# UNITED STATES PATENT AND TRADEMARK OFFICE

APPLICATION NO.	FILING DATE	FIRST NAMED INVENTOR	ATTORNEY DOCKET NO.	CONFIRMATION NO.
10/766,219	01/28/2004	Michael W. Stephens	STEPHENS 1	2889
31704	7590	04/05/2006	EXAMINER	
JOHN H. THOMAS, P.C. 536 GRANITE AVENUE RICHMOND, VA 23226			TOOMER, CEPHIA D	
			ART UNIT	PAPER NUMBER

# Office Action Summary

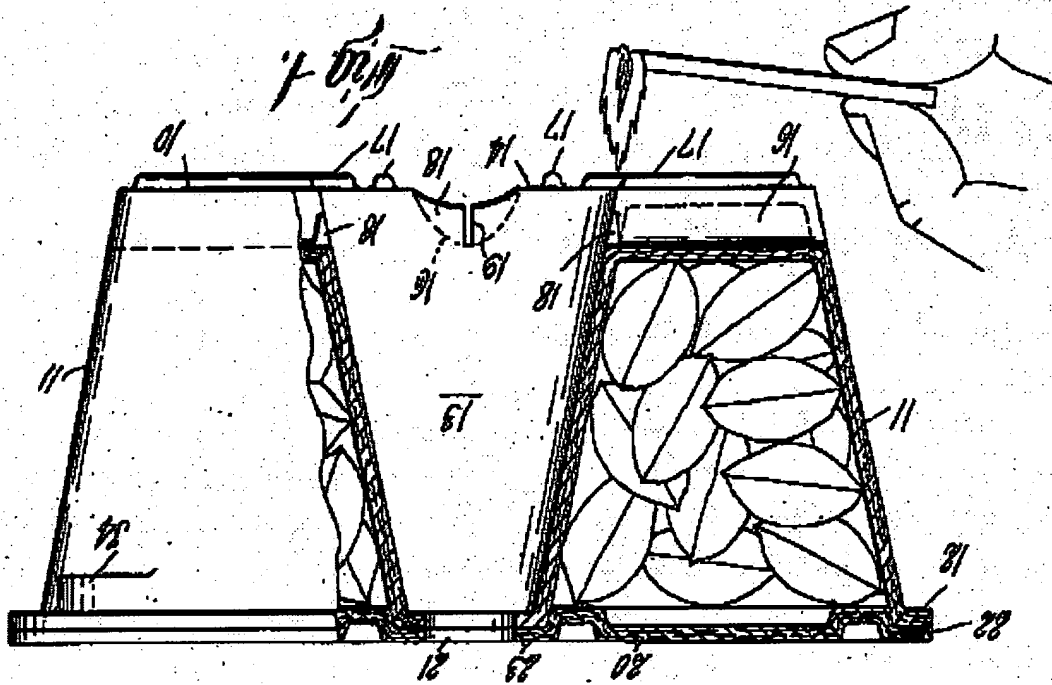
Chaplin teaches a self-kindling fuel package comprising a container for charcoal wherein the container is sufficiently rigid to support the charcoal and is readily ignited to kindle the charcoal (see col. 1, lines 53-62). The container is such configured that it will nest with other containers for shipment (see col. 2, lines 1-7). The container portion has a base wall upstanding and preferably outwardly flaring side walls with an upper

horizontal, outwardly extending flange. See figure 1. As shown below, the compartment containing the charcoal is cone-shaped wherein the top of the compartment is smaller than the bottom of the compartment; the interior is cone-shaped and wherein in a cross sectional width of the compartment the combustible material inside, the outside width of the top of the cone is less than the width of the opening in the base of the compartment.

Chaplin differs from the claims in that he does not specifically teach that the package is arranged as set forth in the claims. However, no unobviousness is seen in this difference because if one were to flip the package, i.e., the bottom now on top, Chaplin's package would meet the claimed limitations. It is well settled that the reversal

of parts or the rearrangement of parts is deemed to be prima facie obvious. See MPEP 2144.04 VI.

Chaplin does not specifically teach openings in the top and bottom of the package. However, before the package is sealed it would have openings at the top and bottom.
